**COMBINED STAGE 1 AND 2 ROAD SAFETY AUDIT
PROPOSED PUBLIC REALM SCHEME
SALISBURY ROAD
UNIVERSITY OF SOUTHAMPTON**

February 2016

Project Title: COMBINED STAGE 1 AND 2 ROAD SAFETY AUDIT SALISBURY ROAD, UNIVERSITY OF SOUTHAMPTON

3.1 PROBLEM

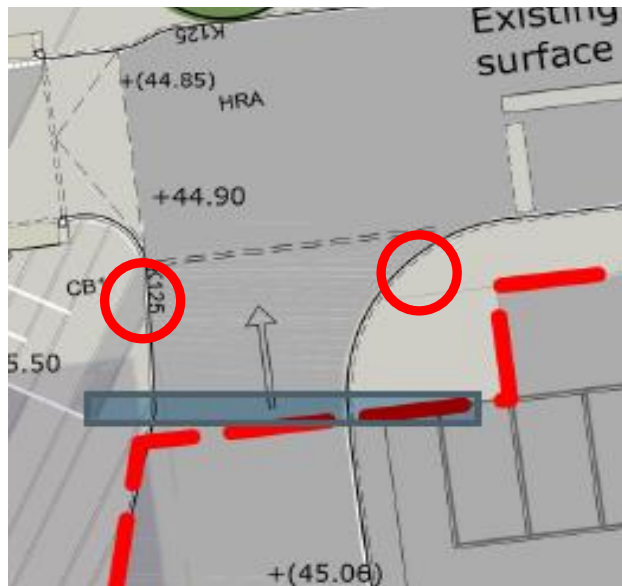
Location: Proposed flush pedestrian crossing on Salisbury Road

Summary: Bollards and street trees could be hazardous to the visually impaired

Bollards are proposed along the north and south side of the crossing point with the likely intention of deterring vehicles obstructing the footway. These bollards could be hazardous to visually impaired pedestrians using the crossing as they may not be aware of their presence. The street trees at the western end, although not on the main desire line, may also form a hazard.

Recommendation: Rationalise the number of the number of bollards to ensure the main desire line remains clear of obstructions. Shorten the length of tactile paving so that it extends as far as the first street tree on the south side of the crossing. A short depth of corduroy warning paving could be provided on the kerb line of the remainder of the flush section on the north and south side to warn the visually impaired of the presence of the carriageway.

Any tactile paving used should where possible, have a colour contrast with the surrounding materials.
